## SECTION 009113 – ADDENDUM TWO

- A. Project Name: 22034.05 MPSD Carver Elementary Additions
- B. Owner: Meridian Public School District, 1019 25<sup>th</sup> Avenue, Meridian, MS 38391
- C. Architect: Dale | Bailey, an Association, One Jackson Place, Suite 250, 188 East Capitol Street, Jackson, MS 39201-2100
- D. Architect Project Number: 22034.05
- E. Date of Addendum Two: 20 October 2023

### Admin Door Schedule

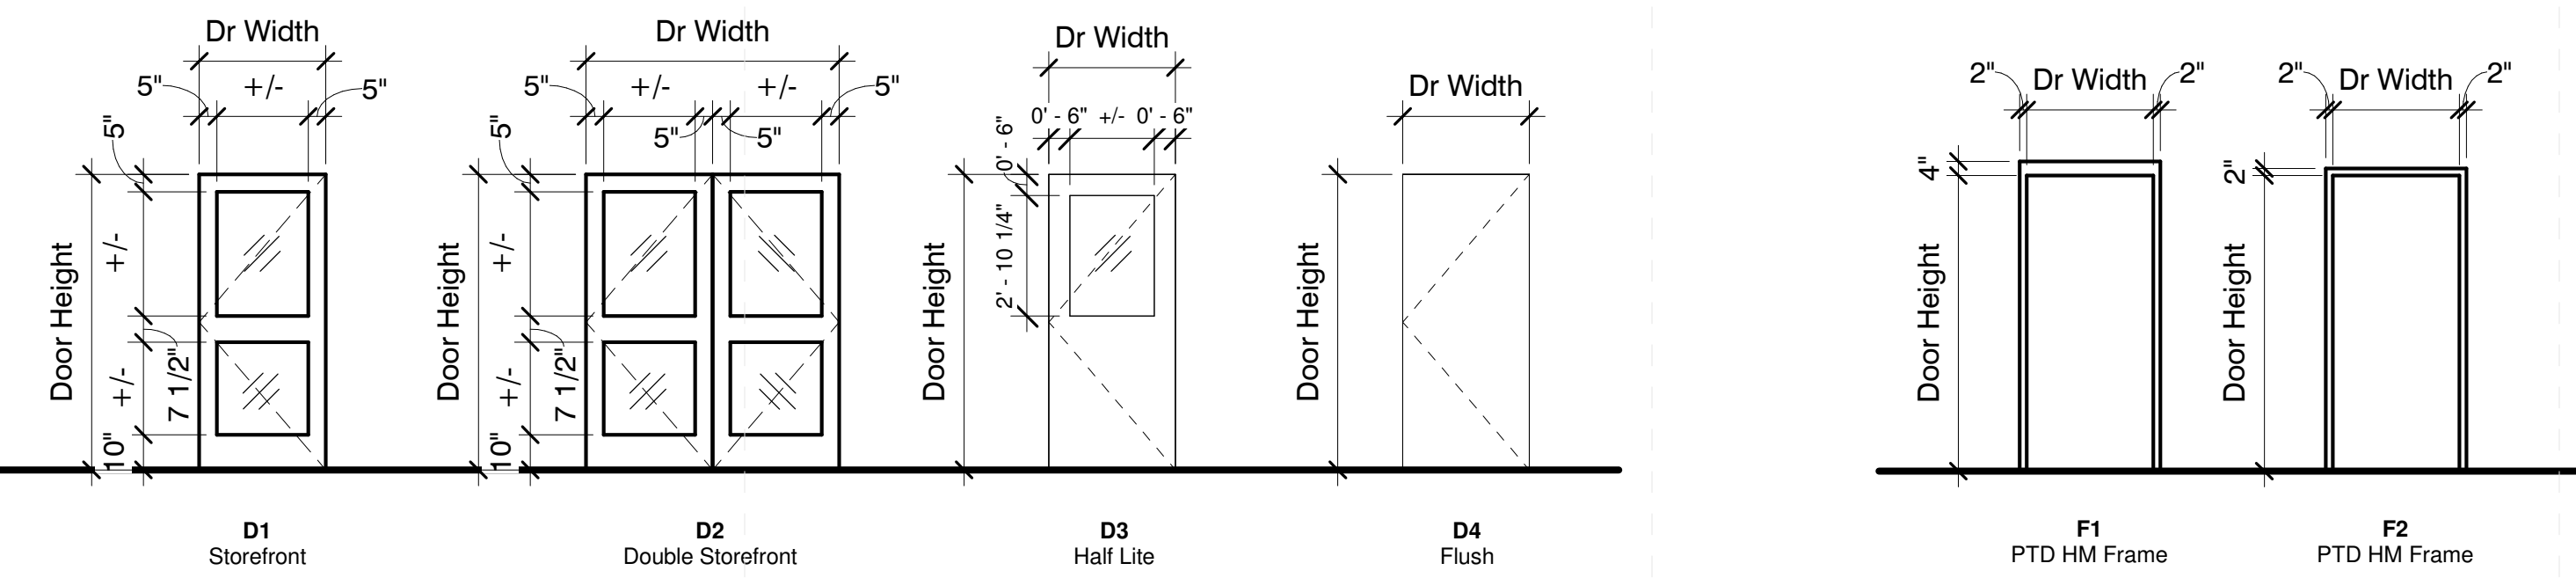
- A. ARCHITECTURAL SHEET A-621 – DOOR SCHEDULE (Re-Issued). Delete this sheet in its entirety and replace it with the attached. Updated hardware schedule for existing doors to be used in conjunction with the existing hardware allowance.
- B. ARCHITECTURAL SHEET AE101 – E DOOR HARDWARE (New). Add to drawings. Electronic Door Hardware Sheet: additional hardware schedule for existing & new door hardware.
